MAJOR ELECTRICITY USERS' GROUP

Powerco CPP proposal

- 1.1. This is a submission by the Major Electricity Users' Group (MEUG) on the Commerce Commission (CC) paper, Invitation to have your say on Powerco's proposal to change its prices and quality standards – Issues to explore and consider, 18 August 2017 (the "issues paper").¹
- 1.2. Attached is an expert report by Mike Hensen of NZIER, Powerco CPP application, Advice to MEUG for Commerce Commission submission, 22 September 2017.
- 1.3. An indication of the recurring theme in this submission that we don't think the CPP proposal leaves consumers better off compared to a DPP counterfactual is captured in the following extract from the NZIER report key points summary:

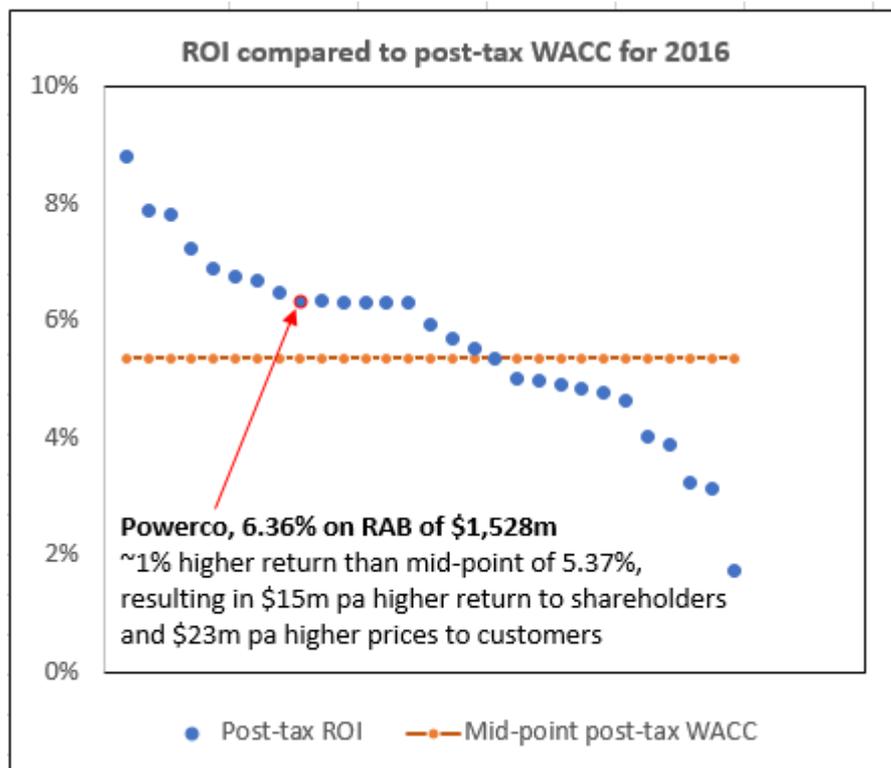
- 2.53. Next, we considered returns to Powerco’s shareholders. The graph below illustrates the post-tax ROI in 2016 for all 29 EDB ranked from highest to lowest with Powerco’s ROI in red and marked with an arrow and explanatory text box.²³ Using this example Powerco earned a ROI of 6.36% which is greater than the regulated mid-point post tax WACC of 5.37% resulting in a \$15m higher return to its owners and, after tax, customers paid \$23m higher prices for that year.²⁴

- 2.54. From this initial analysis MEUG does not believe Powerco's owners have made sacrifices in order to meet necessary expenditure. It begs two questions
